**AGENDA**  
**CASCADE CHARTER TOWNSHIP PLANNING COMMISSION**  
**MONDAY, May 19, 2025**  
**6:00PM**  
**2870 JACKSMITH AVE SE**

**Case #25-3885 – Public Hearing**

## PLANNING COMMISSION STAFF REPORT

STAFF REPORT: Case # 25-3885  
REPORT DATE: May 14, 2025  
PREPARED FOR: Cascade Charter Township Planning Commission  
MEETING DATE: May 19, 2025  
PREPARED BY: Andrea Hendrick, Community Planning & Development Director

Sheet title:  
**LANDSCAPE PLAN**

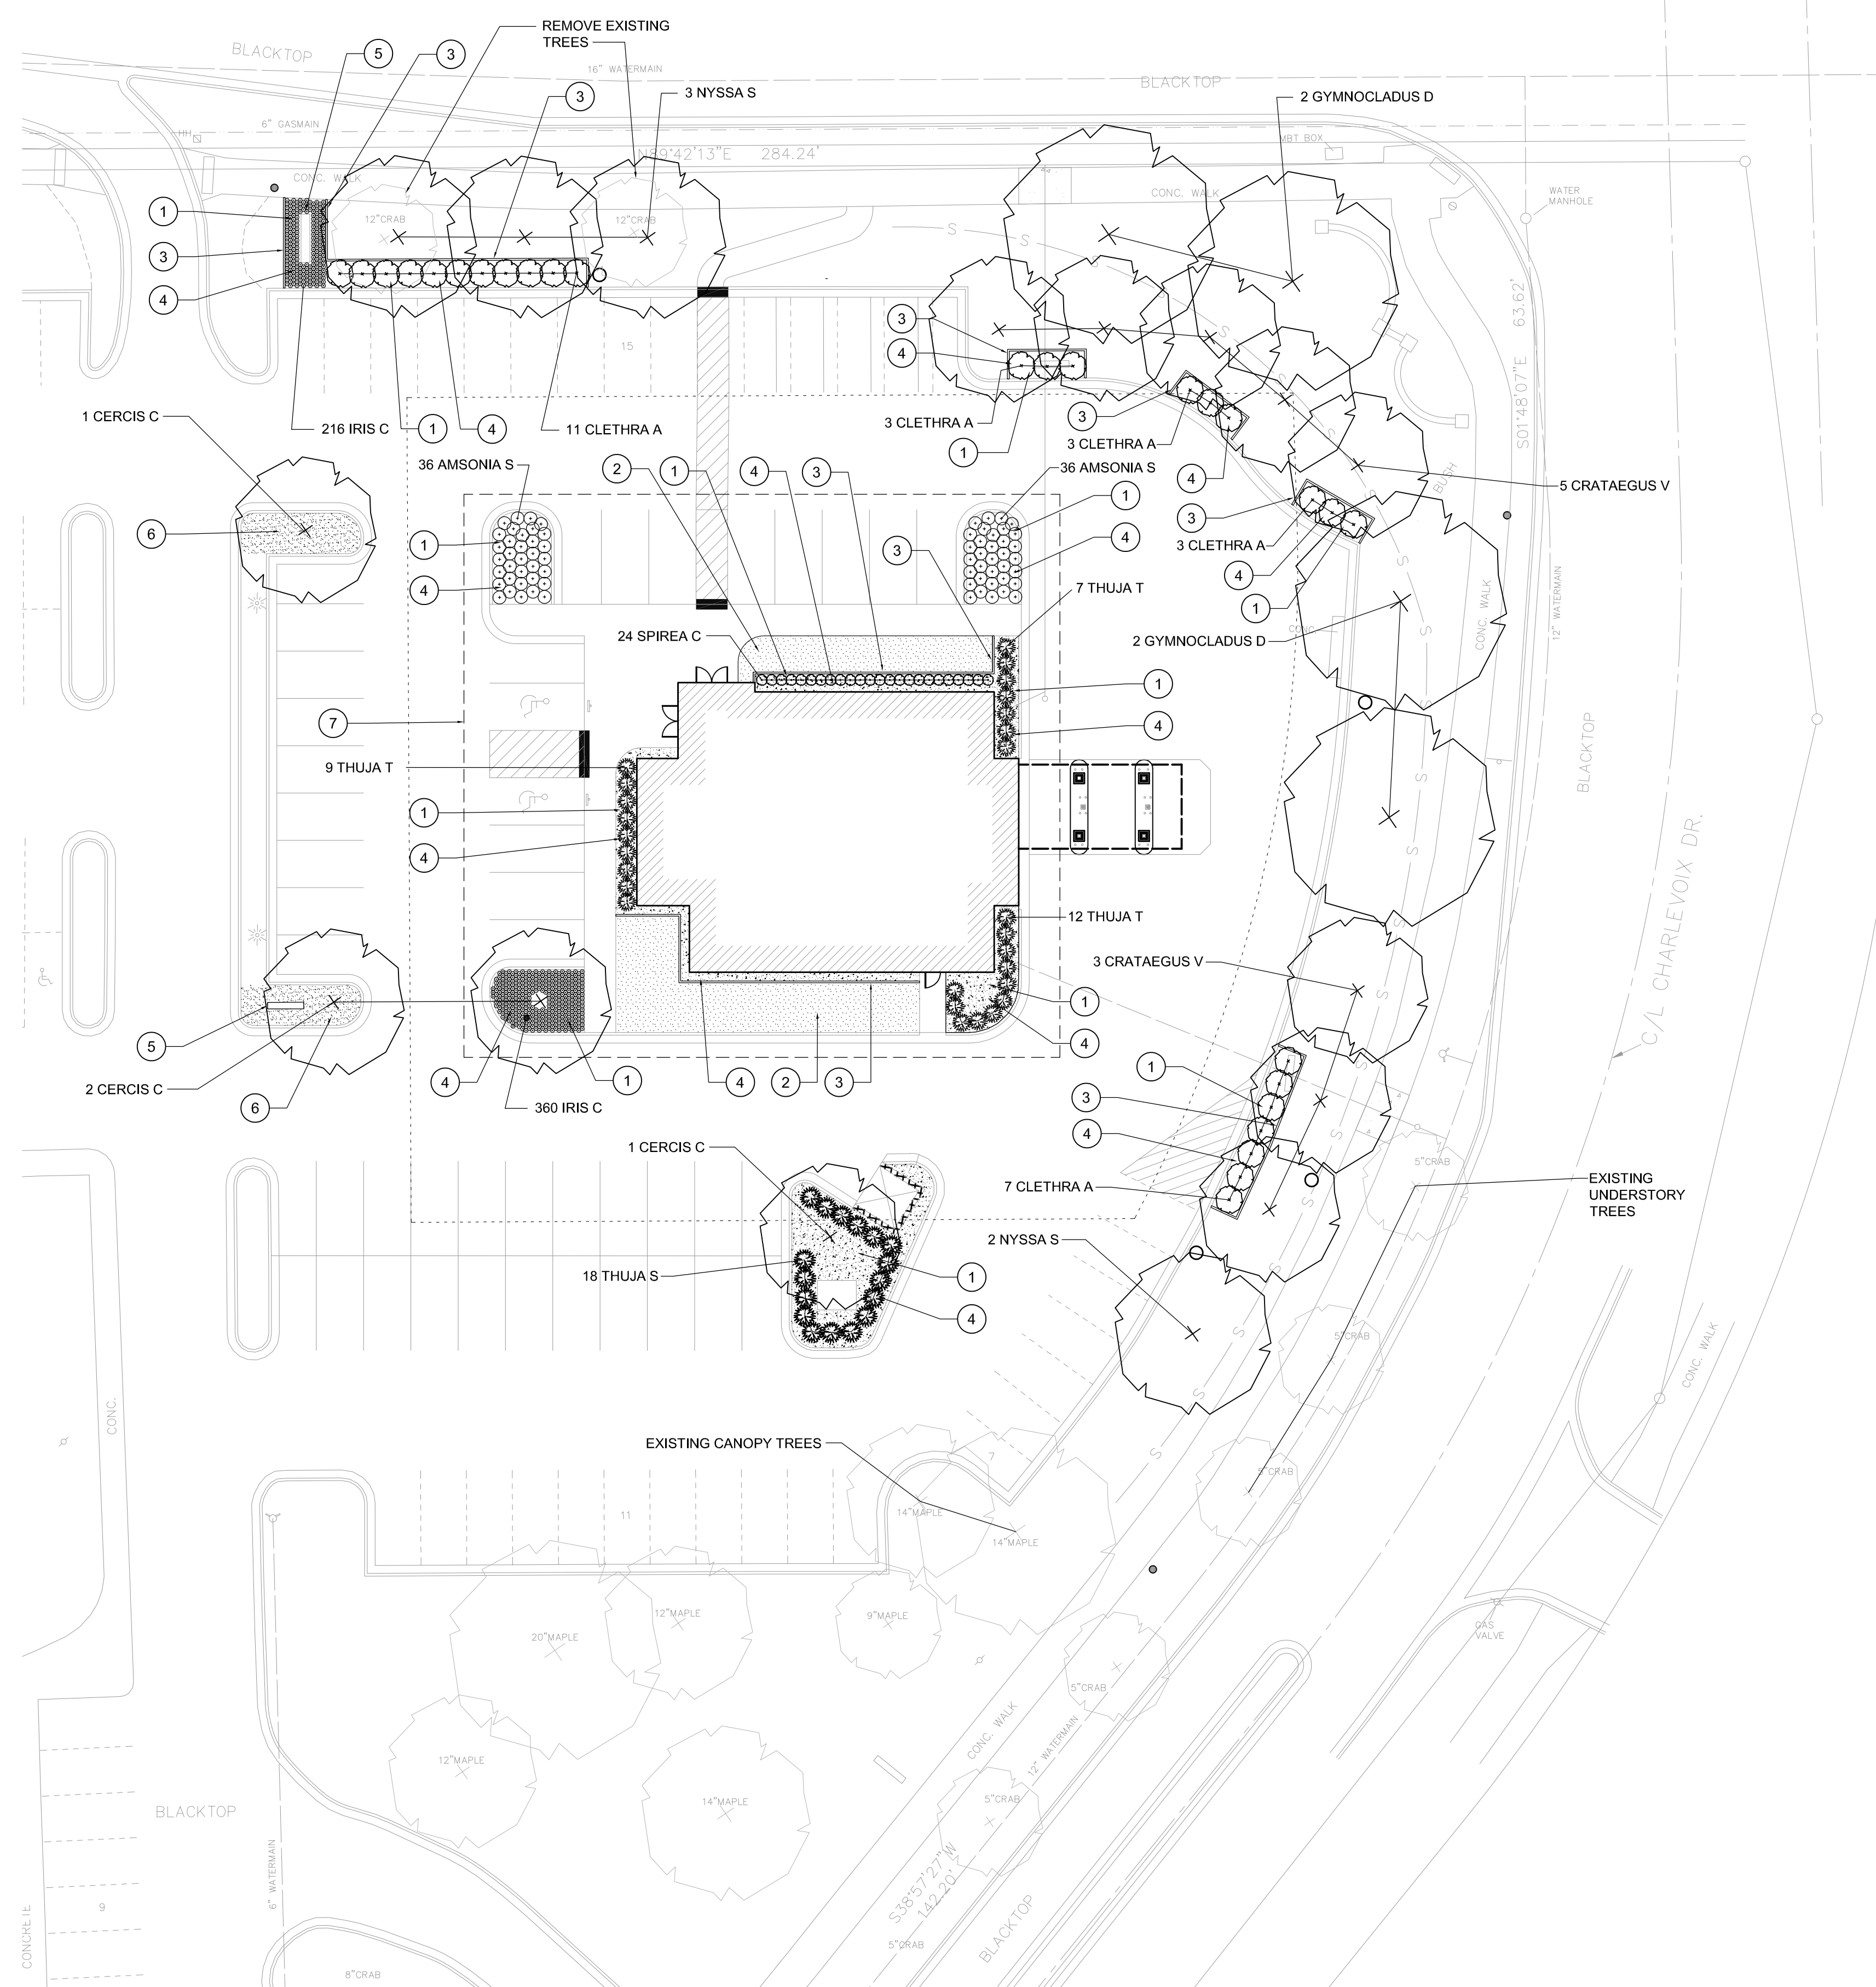
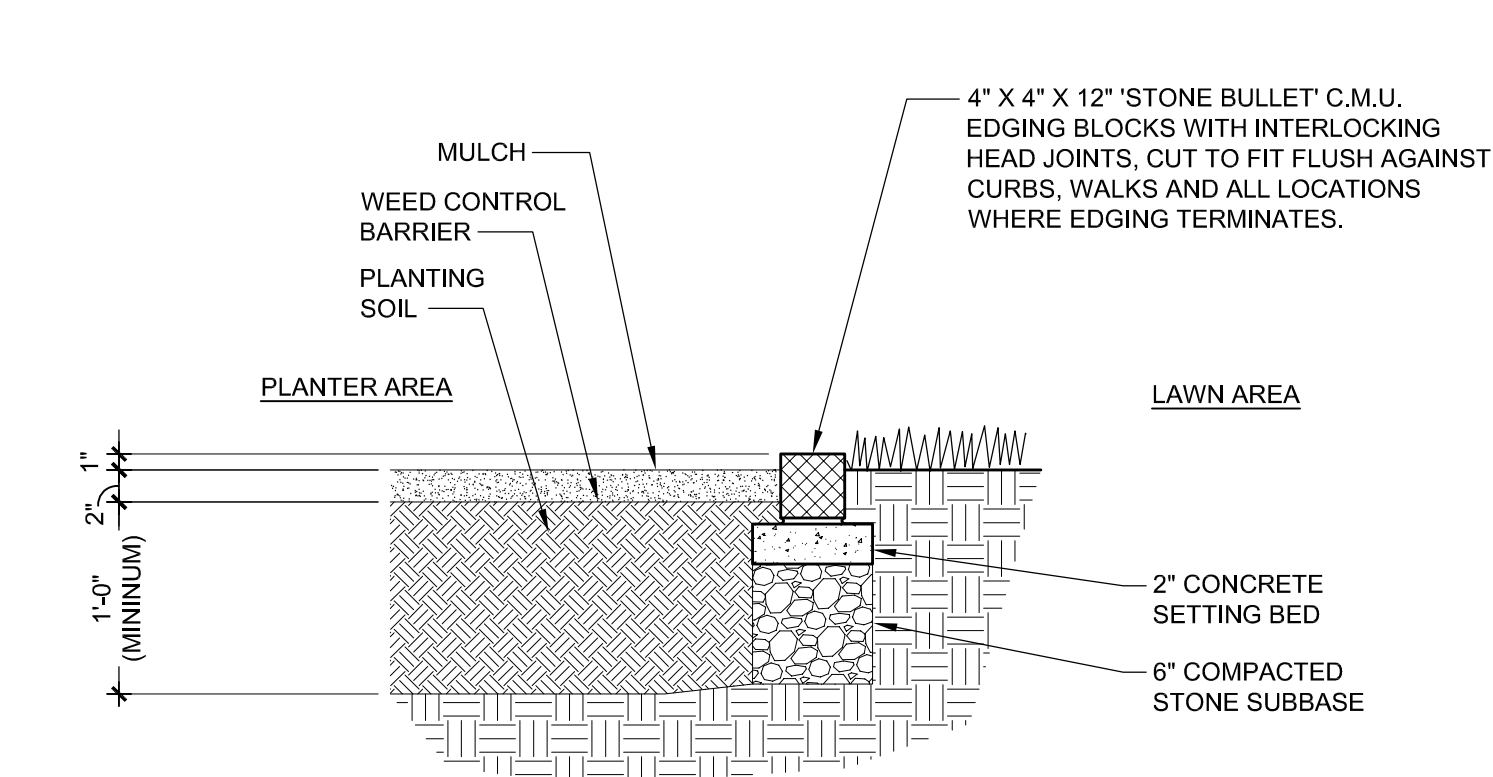
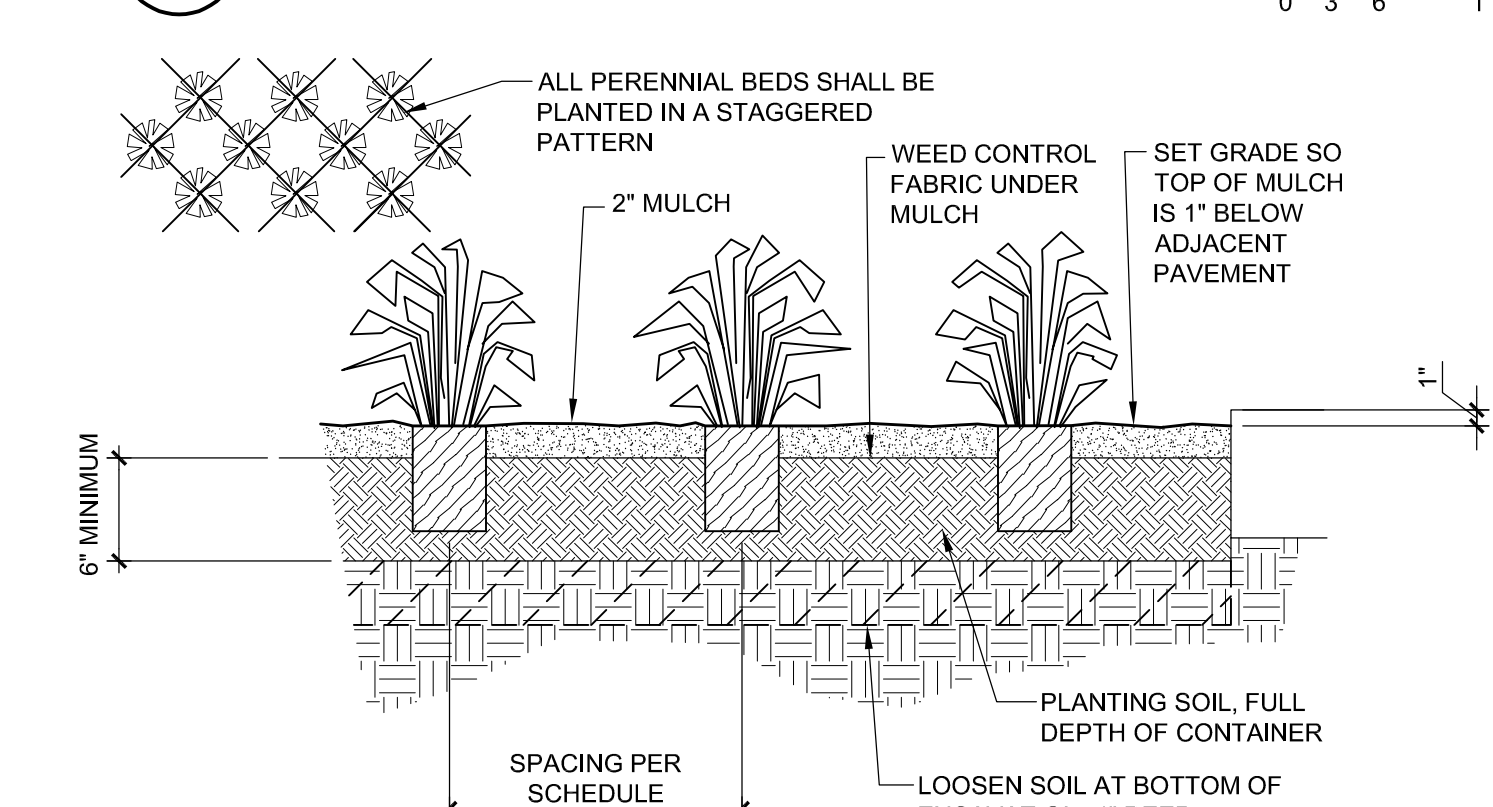
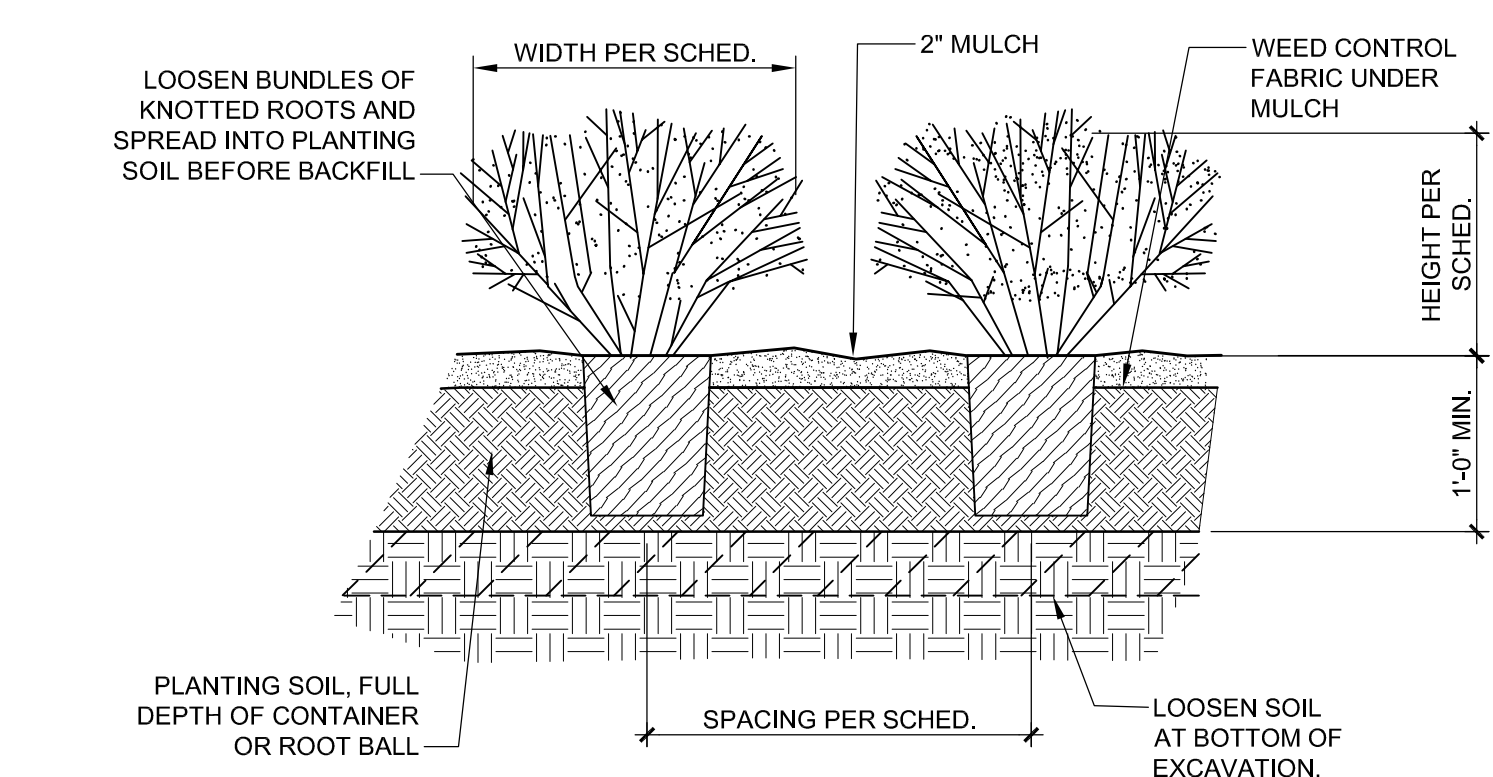
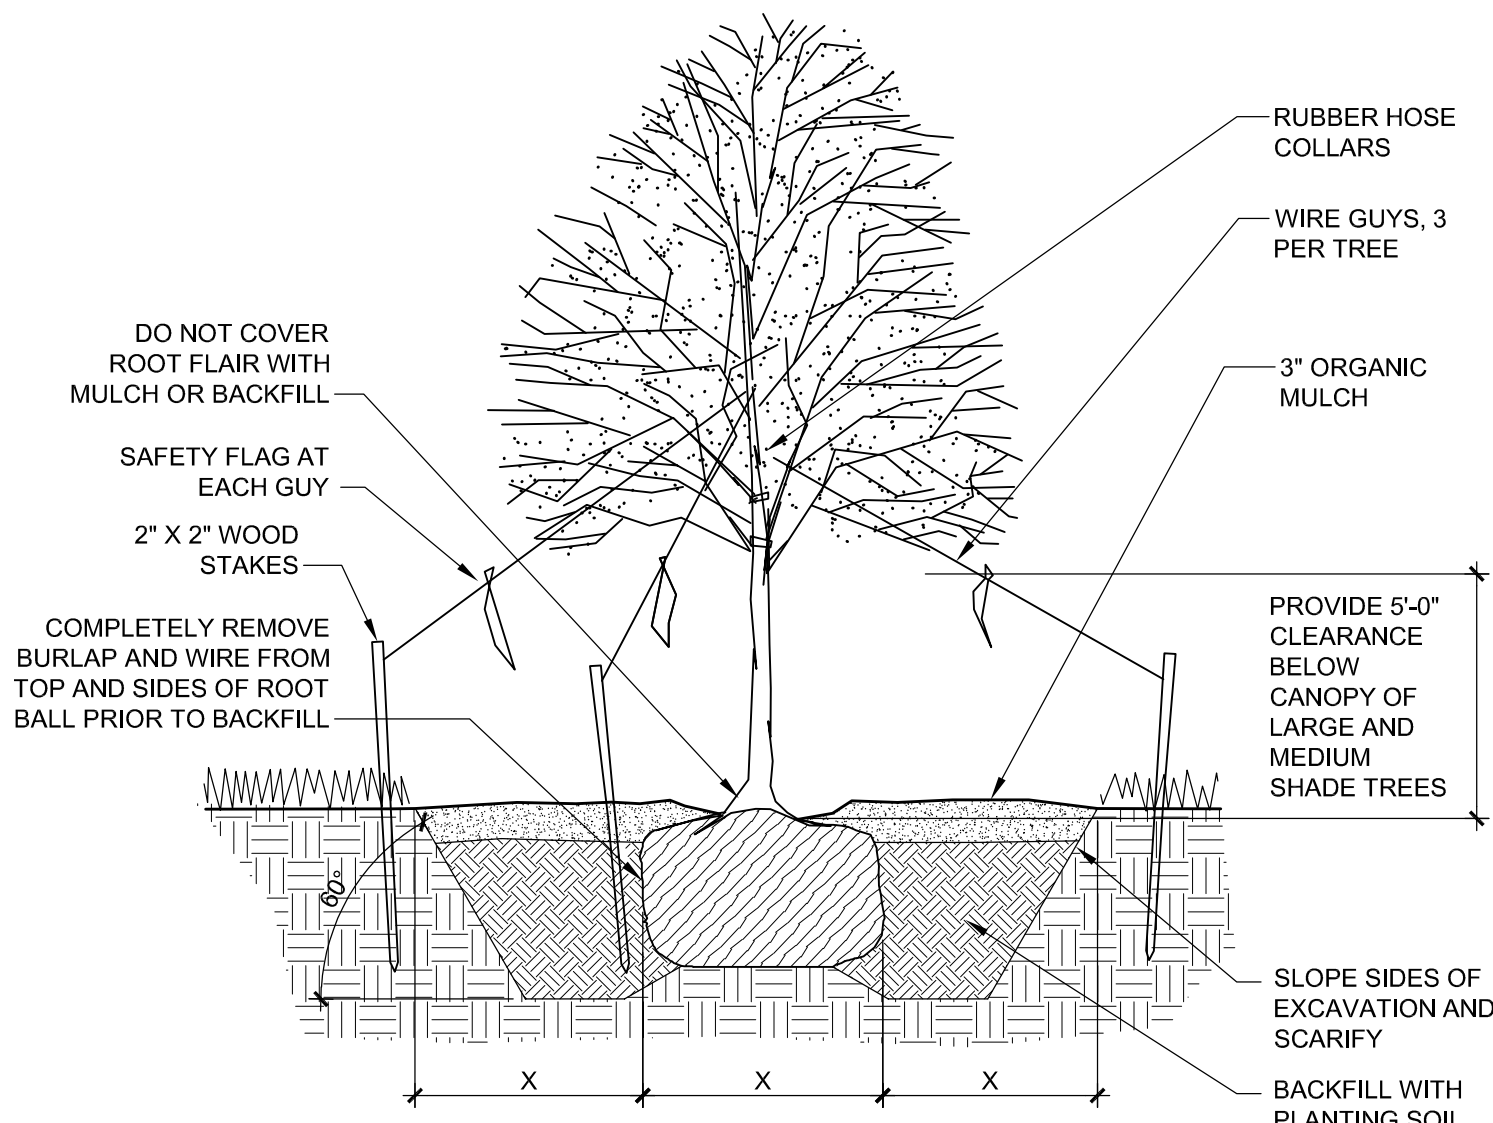
The proposed landscaping plan does not meet the buffer yard requirements of the Zoning Ordinance. The requirements for canopy and understory trees are not met along any of the property lines. While an adequate number of shrubs can be found throughout the site, The required bufferyards on the south and west side are not compliant with Chapter 20 of the Zoning Ordinance or the additional standards of the Centennial Park Overlay. The west property line has essentially no plant material contributing to a bufferyard. Significant additional plant material is required to meet the standards of the Ordinance.

Planning Staff recommends that the applicant provide the required additional trees, however allow the applicant to disperse the trees throughout the site or replace the canopy trees with understory or additional shrubs. Additionally, the large berm south of proposed site could support additional landscaping and contribute to the overall site development. The Zoning Ordinance allows the Planning Director to review and approve administratively.

6. The applicant meet the sign requirements of the Centennial Park Overlay.
7. The applicant provides the required bufferyards and planting requirements on the **[EAST]** side of the property.
